## **ALERT SERVICE BULLETIN**

**429-14-15**

**MODEL AFFECTED:** 429

**SUBJECT:** GOODRICH EXTERNAL HOIST

Figure 1. Lower limit for the 600 lb capacity hoists

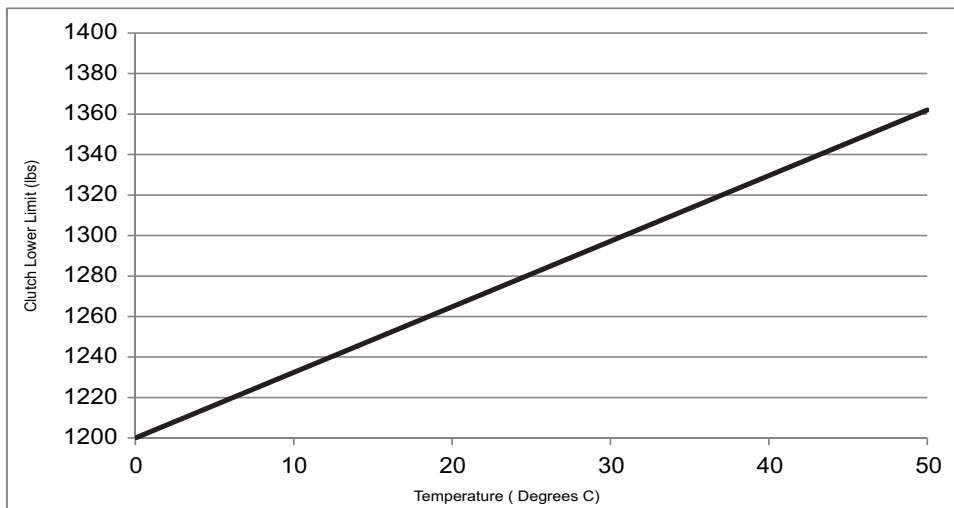
- a. If the test results indicate a value above the acceptable lower limits per Table 2, Figure 1 of the Goodrich ASB 44301-10-18, Revision 6, proceed with step 3.

- b. If the test results indicate a value below the acceptable lower limit per Table 2, Figure 1 of the Goodrich ASB 44301-10-18, Revision 6, remove the hoist from service before the next hoist operation.

Figure 3. Load check flowchart

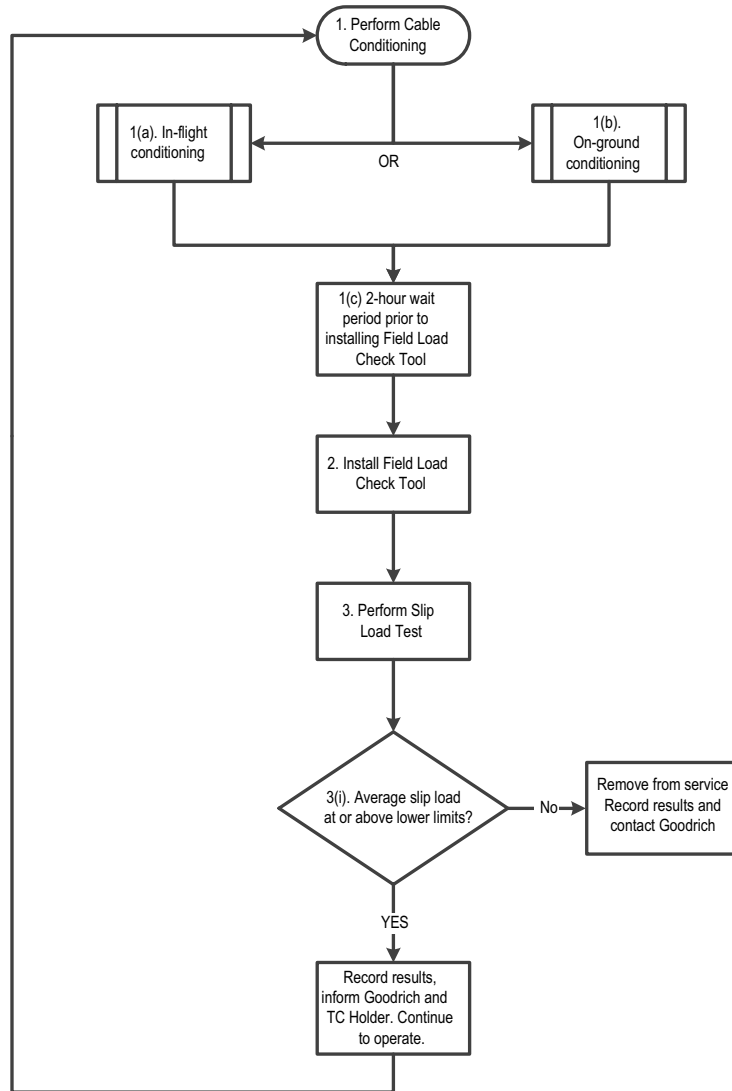
- (a) Press the Peak button on the load meter.
- (b) Using the box wrench provided in the kit, tighten the hex nut on the load check tool at a rate not exceeding 90° per second to increase the load on the cable until the clutch slips or until reaching 1500 lbs. If the clutch does not slip at less than 1500 lbs, then record the load as 1500 lbs and stop increasing the load. Decrease load to 600-700 lbs and continue at step 3d.

- (i) If the test results indicate a value above the allowable limits per Table 1, record the results, inform Goodrich and the TC holder, and continue operations.
- (j) If the test results indicate a value below the acceptable lower limit per Table 1, obtain a return authorization for the failed hoist using the standard RMA process through Goodrich at the address listed below. Send results of testing to Goodrich.
